ADDENDUM 1

ADDENDUM DATE: April 9th, 2019

PROJECT: OCSC Expansion - Phase 1, Seymour Center
2551 Homestead Rd.
Chapel Hill, NC 27516

The following is a list of changes that have been made to the plans since the issuance of bid documents. These changes are as a result of Town review comments.

C5-30

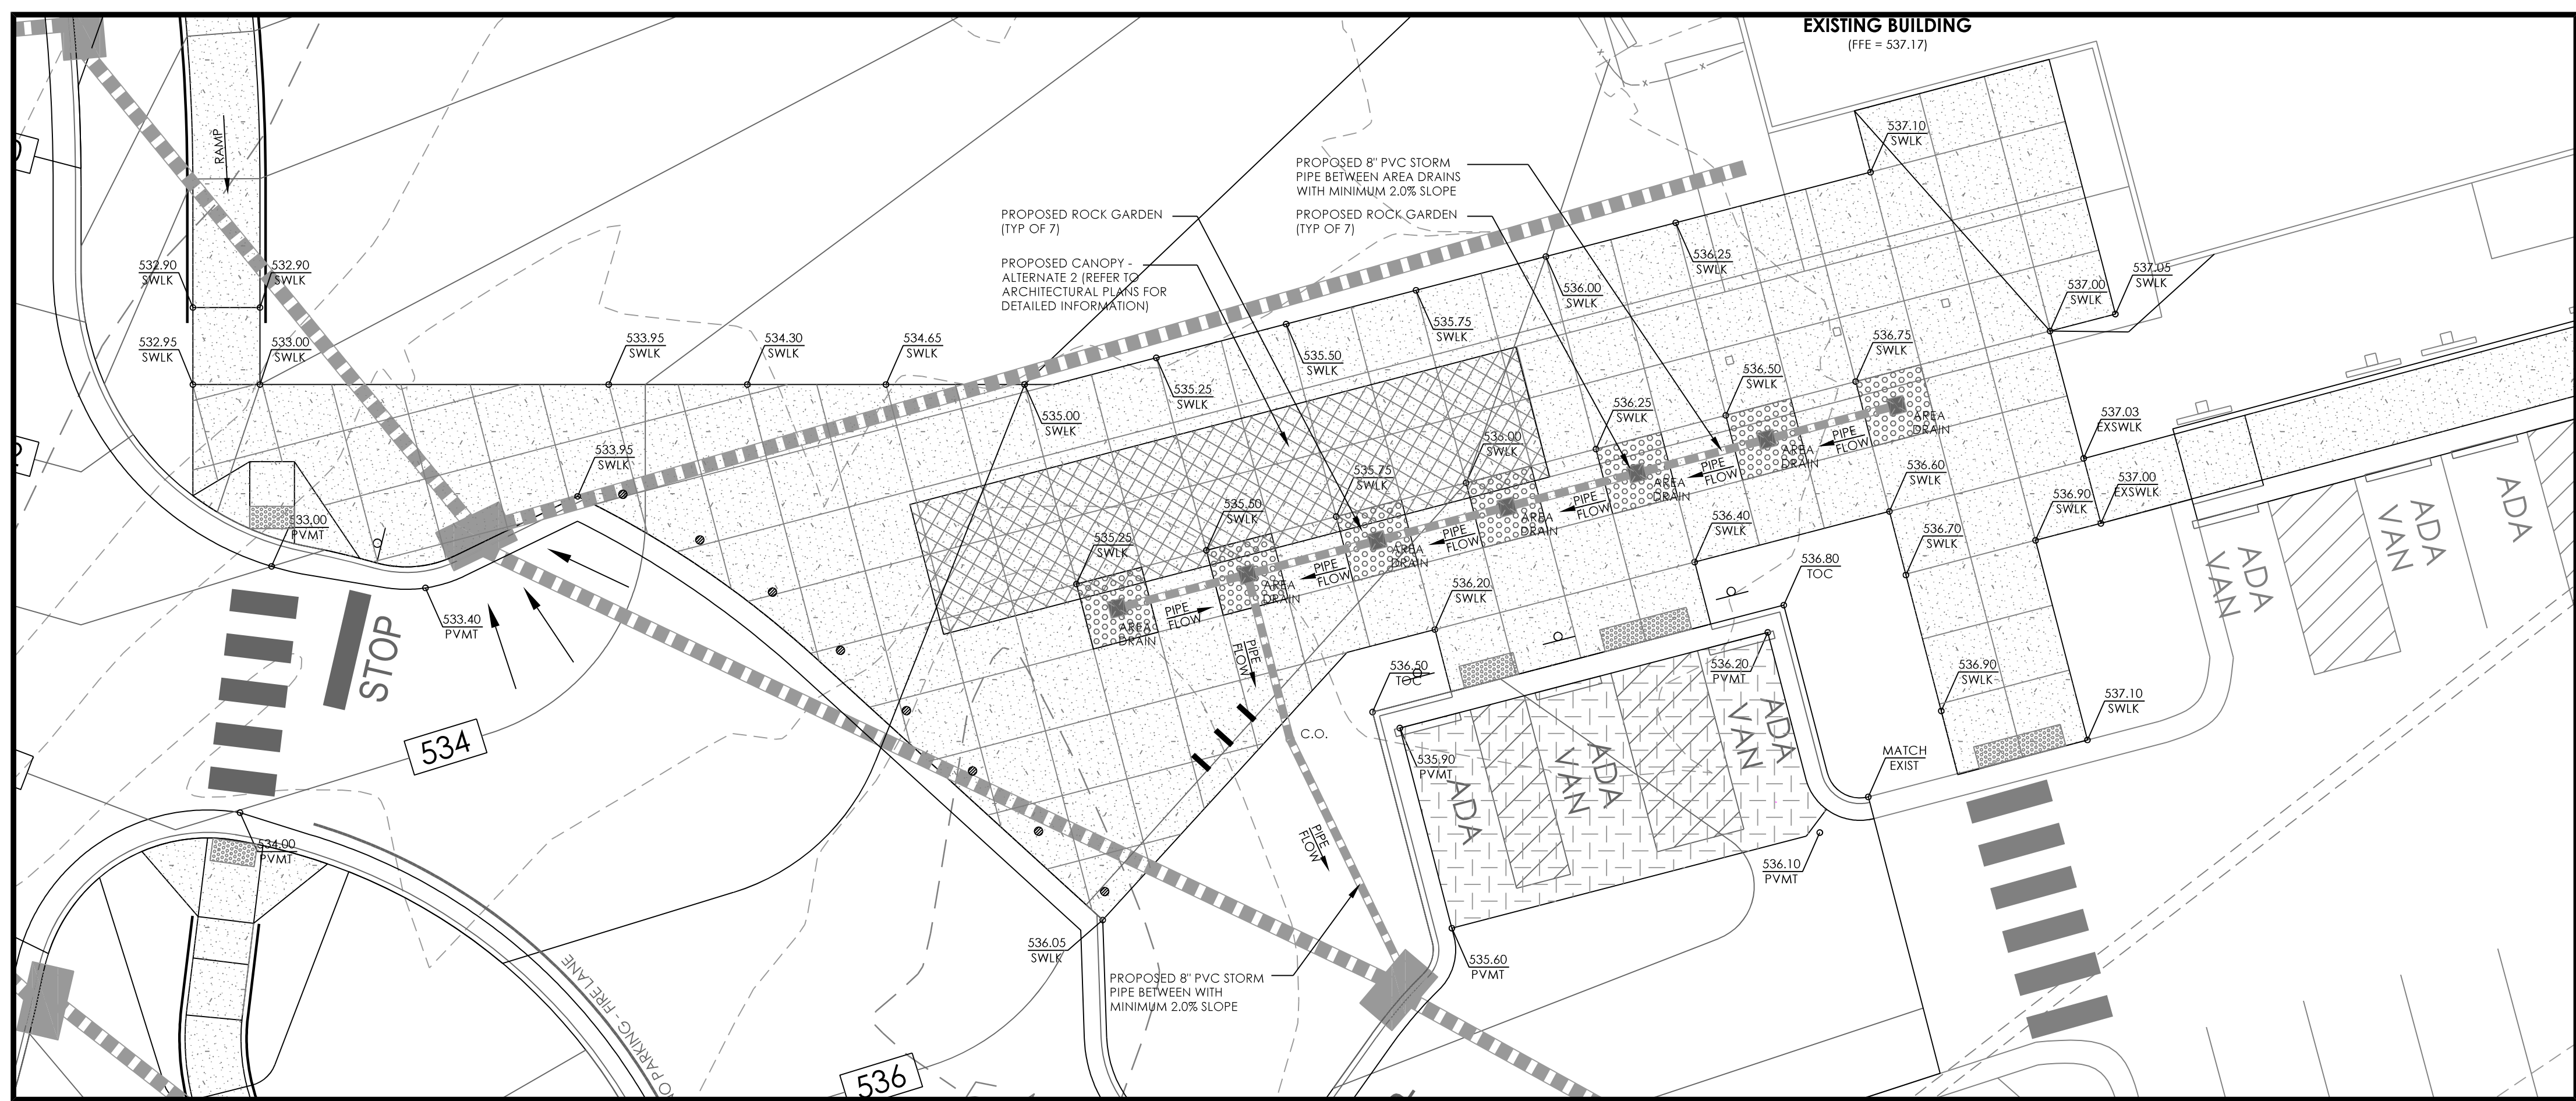
5. Several sections of the storm drainage system on site have been revised including elevations and pipe sizes. (Refer to sheets C5-30 and C8-00)

C6-30

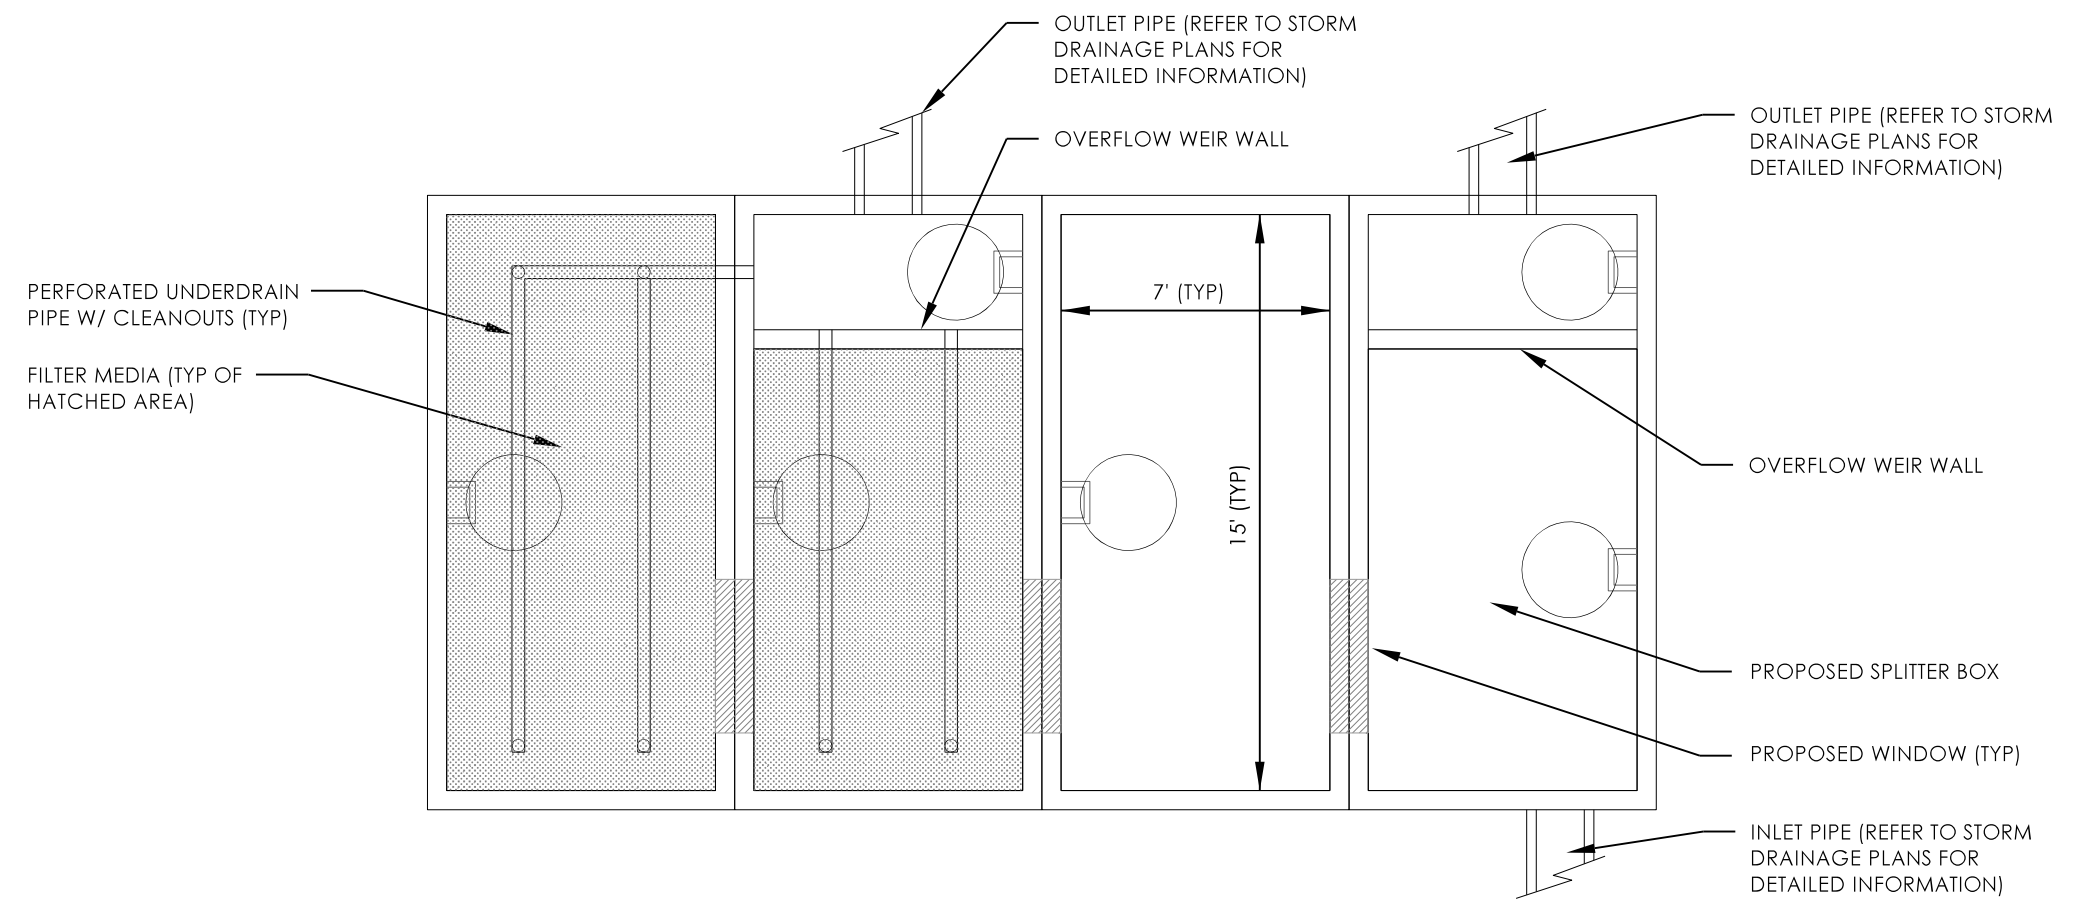
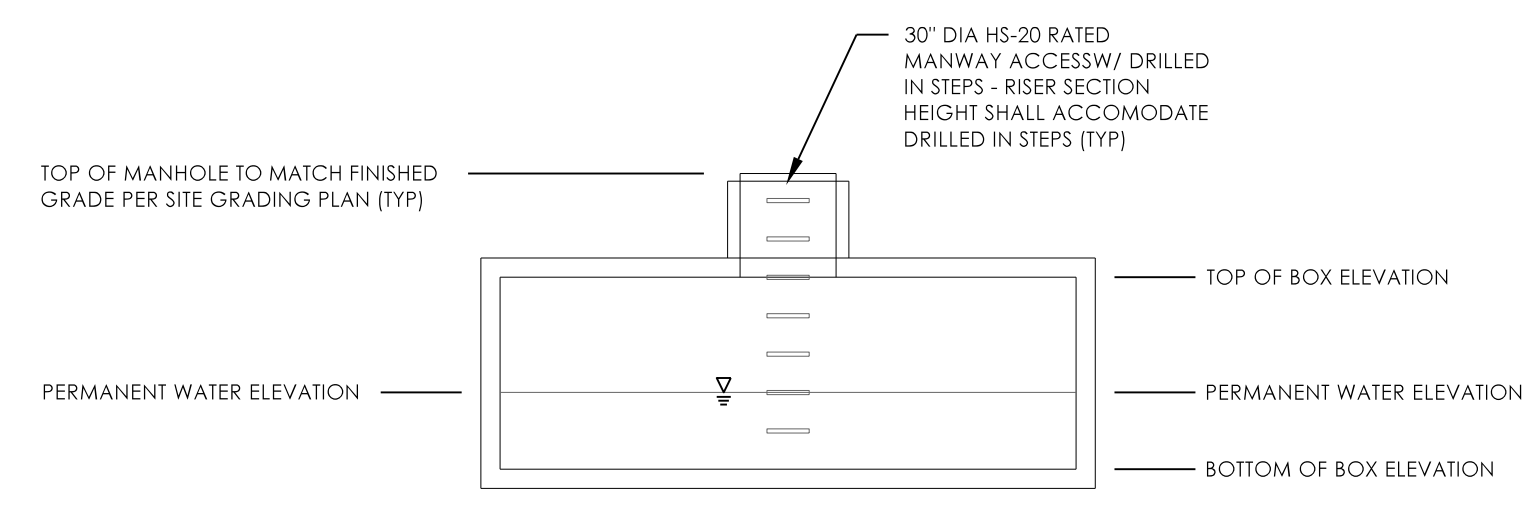
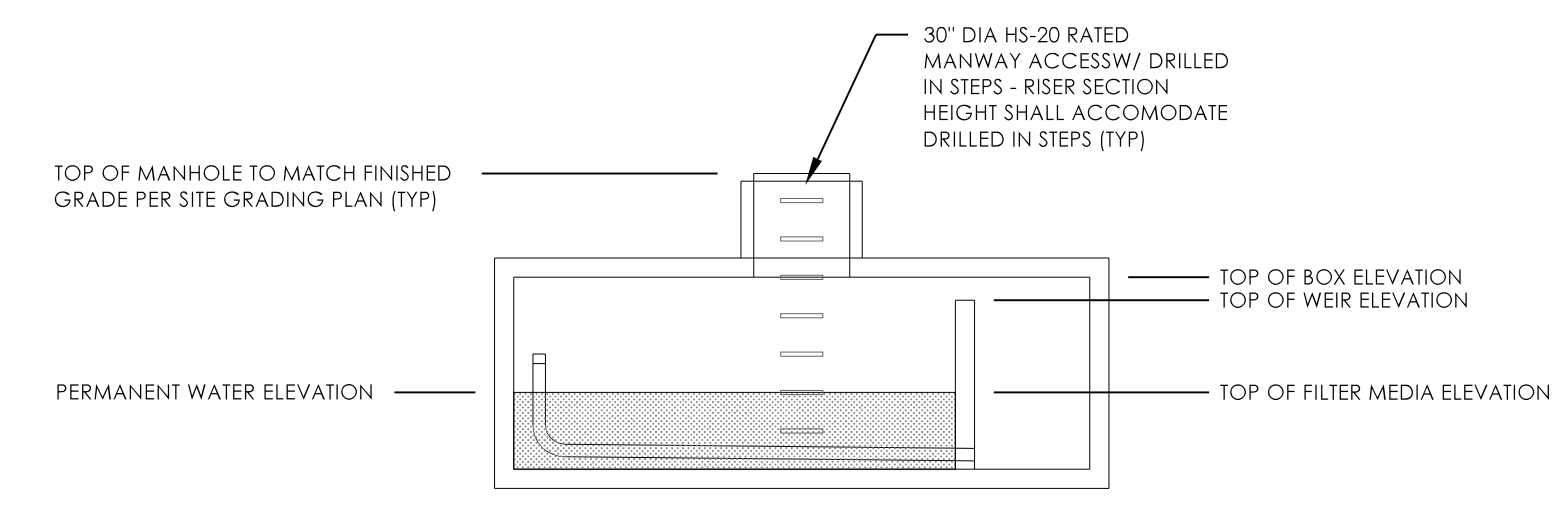
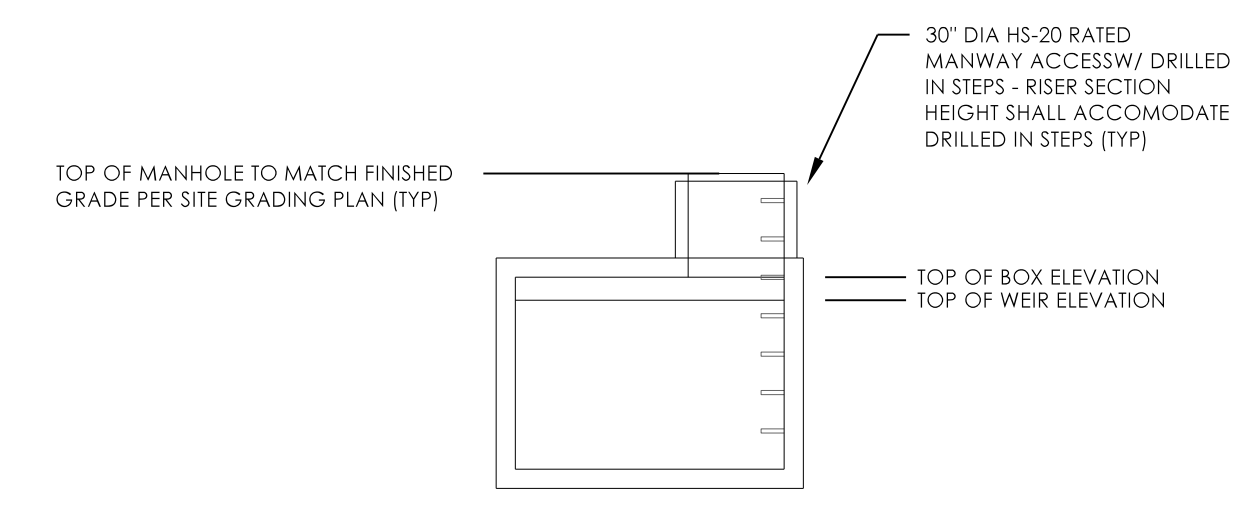
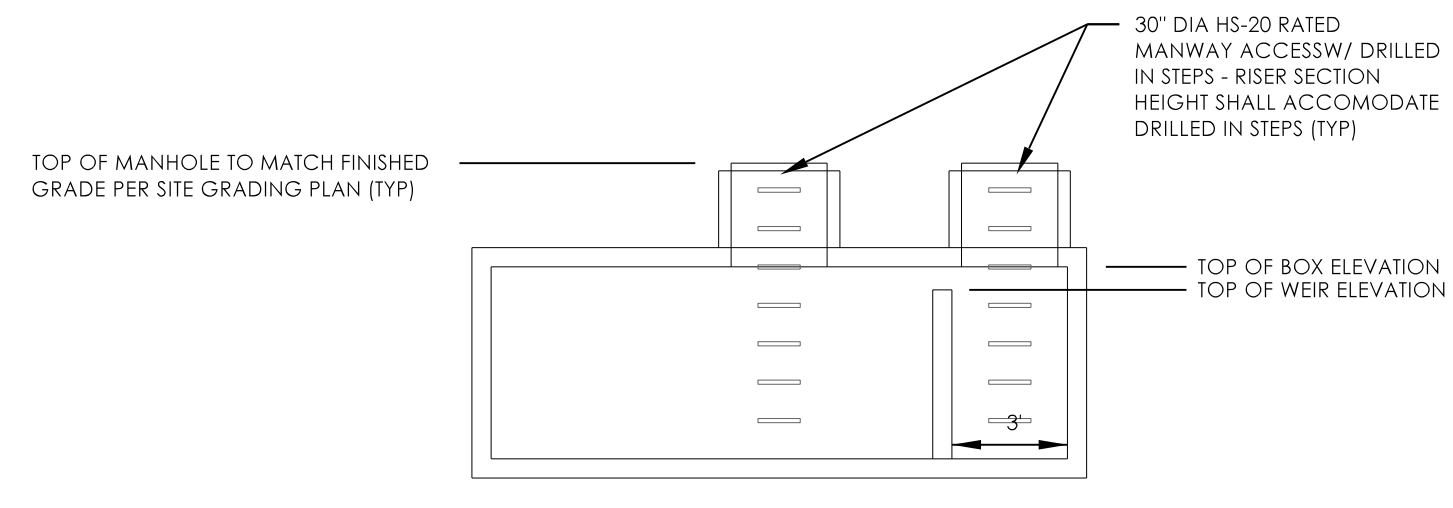
2. Sheet C0-02 has been changed to C0-03. Sheet C0-02 has now been used for required OWASA documents. (Refer to sheets C0-02 and C0-03).
3. A sand filter has been added to the north edge of the project site near the Homestead Road public right-of-way. (Refer to sheets C5-20 and C6-30)
